Civil & LS Plan (3.17.25) 28229 Manzella Dr (Markups & Summary).pdf

NEW OFFICE / STORAGE

38229 MANZELLA DRIVE, SLIDELL, LOUISIANA

4 (1)

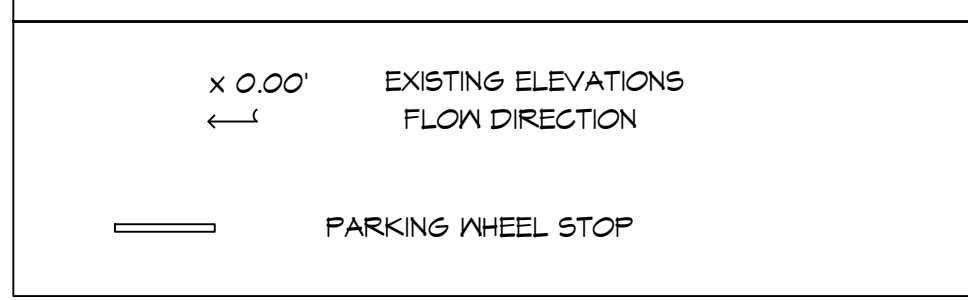
1. Provide scaled landscape plan stamped by licensed Landscape Architect per code (with phone and email contact).
2. Label Plan 'Alternative Compliance Landscape Plan' as this plan differs from code and was achieved via special consideration from Planning Administrator.
3. Provide updated parking calculation on LA Site Plan.
4. All Class A trees must be native and meet min size standards for STP (2-2.5" caliper 10-12' height.)
5. All parking lot islands must be min. 9x18' planting area with 6" curb, Class A tree and living materials below (grass, groundcover or shrubs.)
6. All planted areas must have min. 3" organic mulch (no stone) typ.
- Seed, sod all disturbed areas.
7. LA plan must include certification stamp per code as shown on this page (to be signed by project la prior to calling for final inspection.)
8. Note on plan: "No tree removal will occur with this project.

All existing trees in ROW and on-site to remain unless approved in writing by Dept of Development."

Revised

DRAWING NUMBER: **C100**

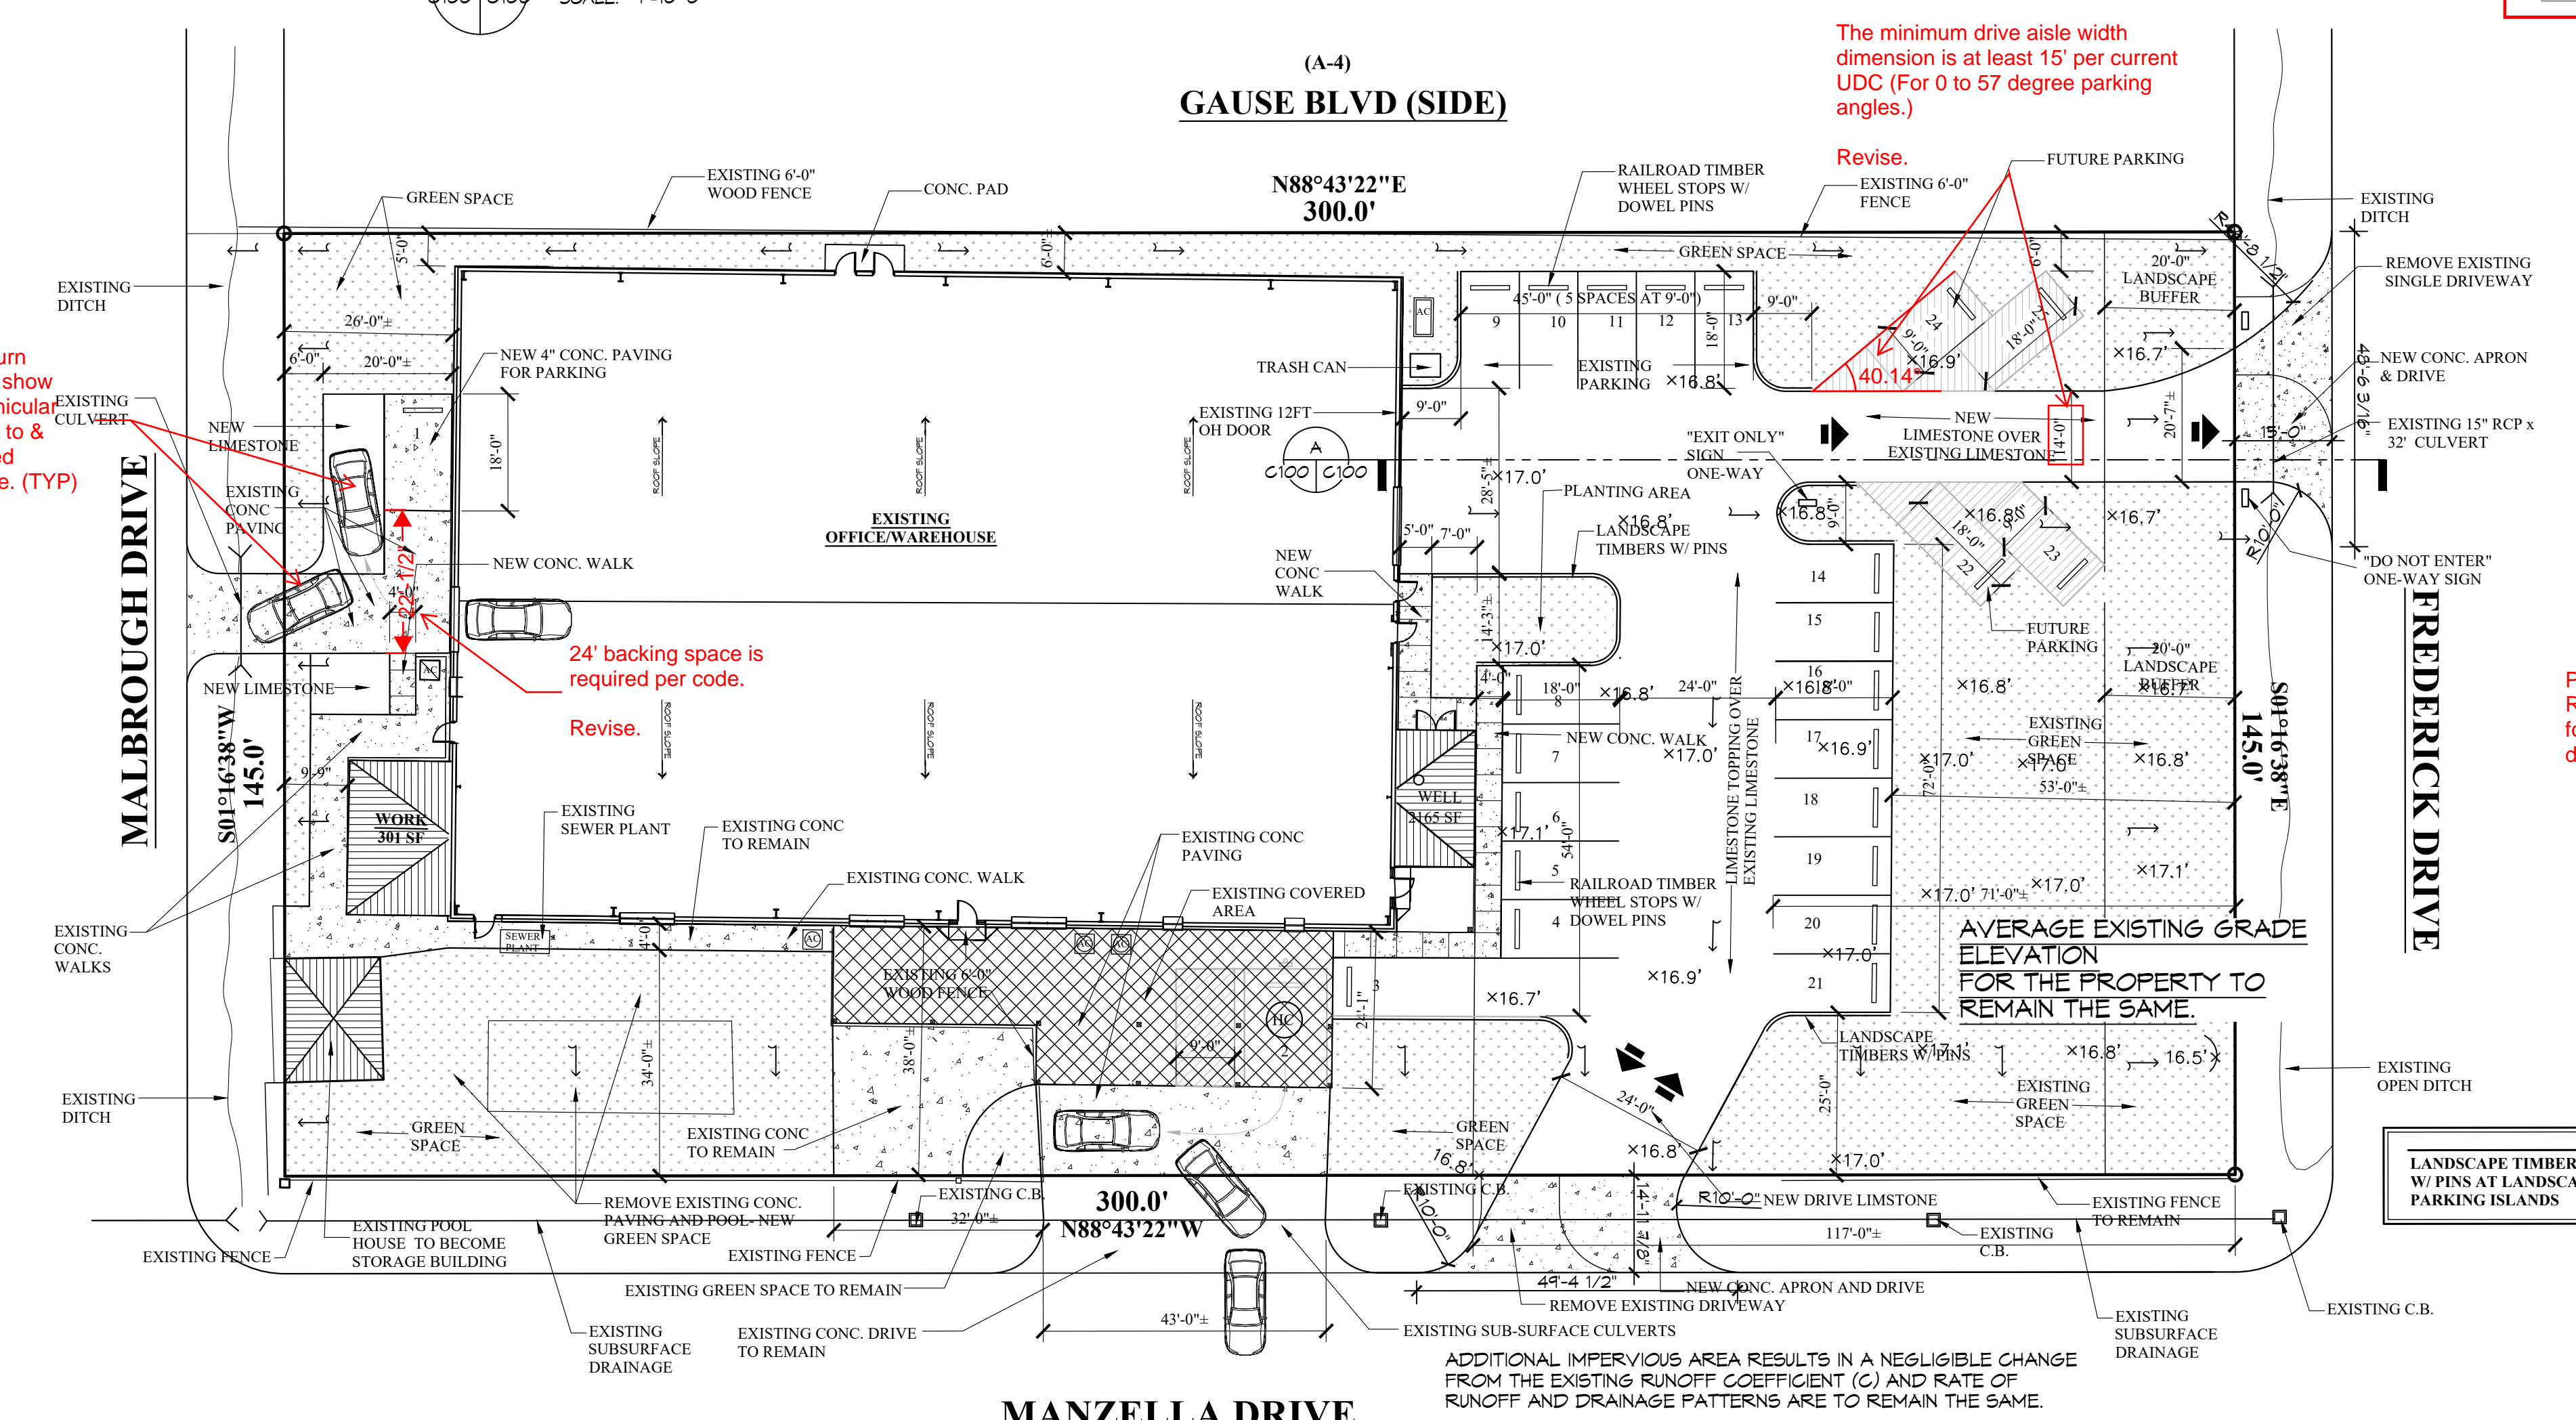
The minimum drive aisle width dimension is at least 15' per current UDC (For 0 to 57 degree parking angles.)

Revise autoturn simulation to show proposed vehicular maneuvering to & from proposed parking space. (TYP)

24' backing space is required per code.

Revise Runoff Coefficient (C) = 0.95 for watertight surfaces per STP Ordinance Sec. 900-6.3(F); Exhibit 900-6-6.

Revise Runoff Coefficient (C) = 0.7 for gravel per STP Ordinance Sec. 900-6.3(F); Exhibit 900-6-6.

Revise Runoff Coefficient (C) = 0.3 for greenspace per STP Ordinance Sec. 900-6.3(F); Exhibit 900-6-6.

(TYPICAL for both pre & post development.)

Provide "Weighted" Runoff Coefficient (C) for both pre & post development.

Provide "Weighted" Runoff Coefficient (C) for both pre & post development.

Revised

Movd parking over to avoid conflict

Revised

Revised

Revised

SITE PLAN- NEW WORK

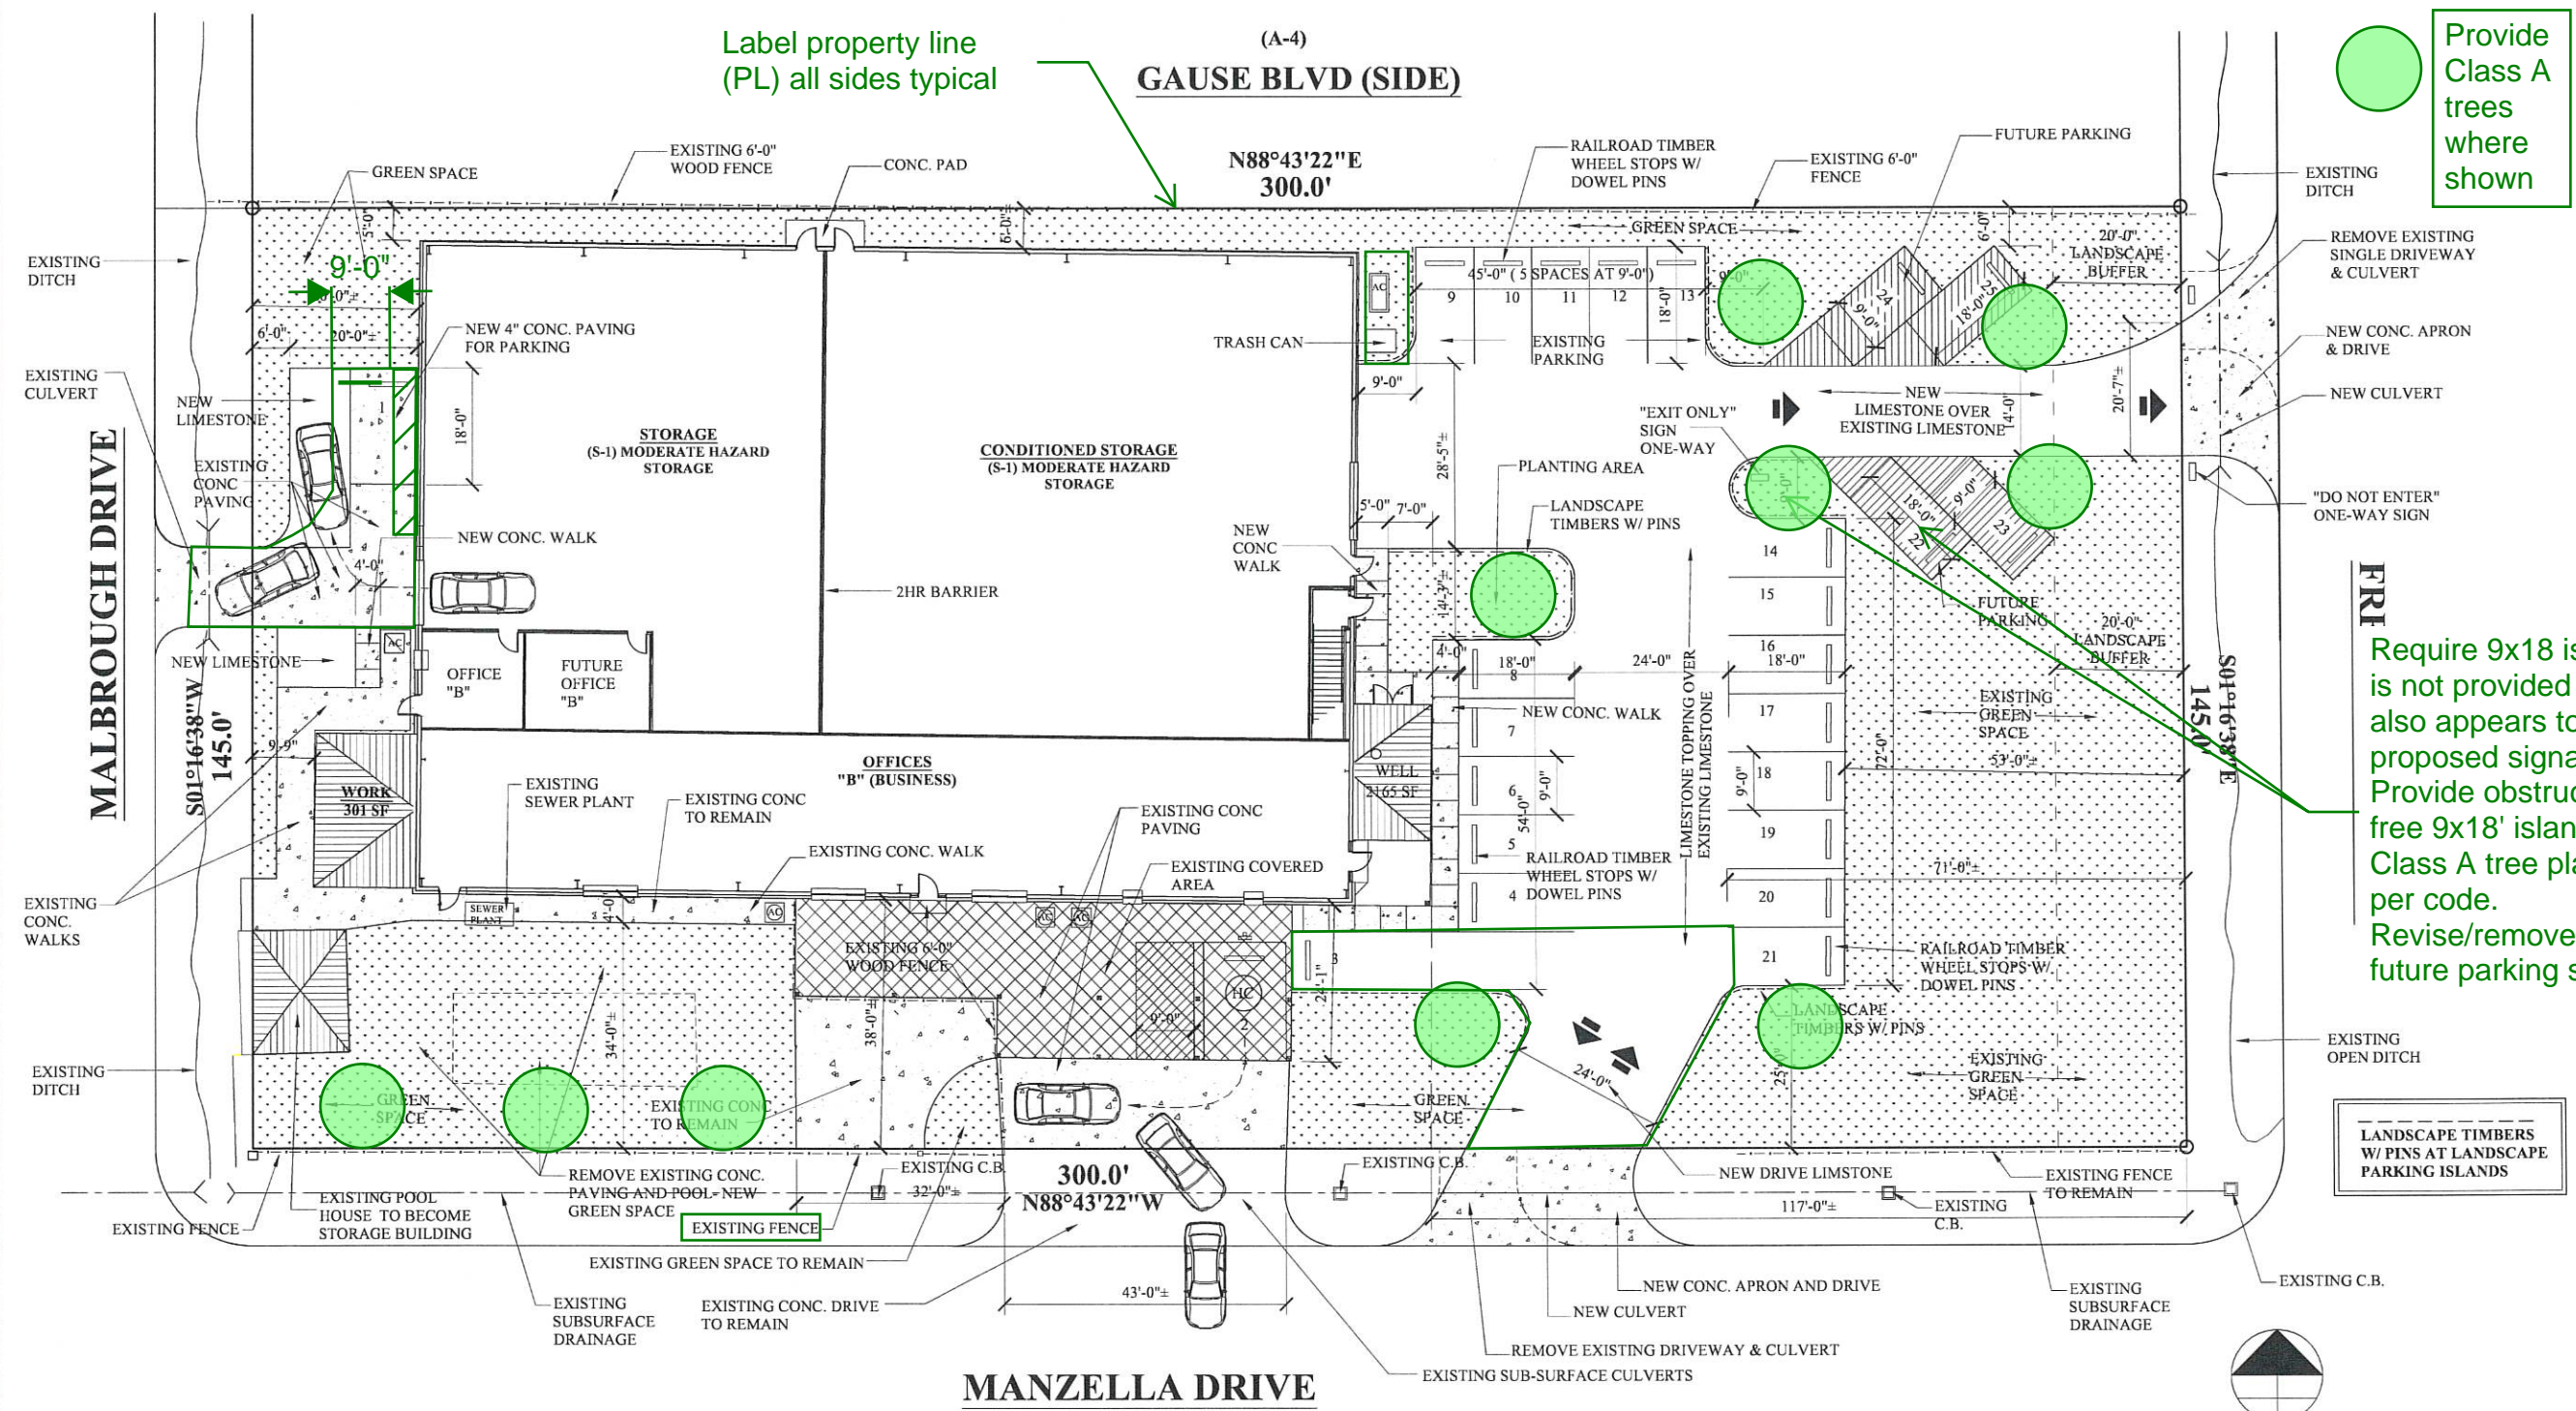
Label height and location of all existing and proposed fences on-site. typical

Island with Class A tree required at end of ea parking space. Is this an existing AC or proposed? If proposed, relocate and provide tree/planting as required by code.

This space is too close to HC parking and is unsafe. Recommend changing entry drive to perpendicular and making this a standard space next to parking spot #4

Provide Class A trees where shown

Require 9x18 island is not provided aqdm also appears to have proposed signage. Provide obstruction free 9x18' island for Class A tree planting per code. Revise/remove this future parking space.

Label property line (PL) all sides typical

Provide 4' pedestrian access/safety space adjacent to bldg per code. Approved for only (1) 9x18' parking space. Suggest widening radius as discussed, not increasing paving further into street buffer.

provide scaled drawing per code

Label property line (PL) all sides typical

Provide Class A trees where shown

Require 9x18 island is not provided aqdm also appears to have proposed signage. Provide obstruction free 9x18' island for Class A tree planting per code. Revise/remove this future parking space.

provide scaled drawing per code

Revised

A/C is existing

Eliminated parking spot

Revised

Parking removed

Revised

Revised

Revised
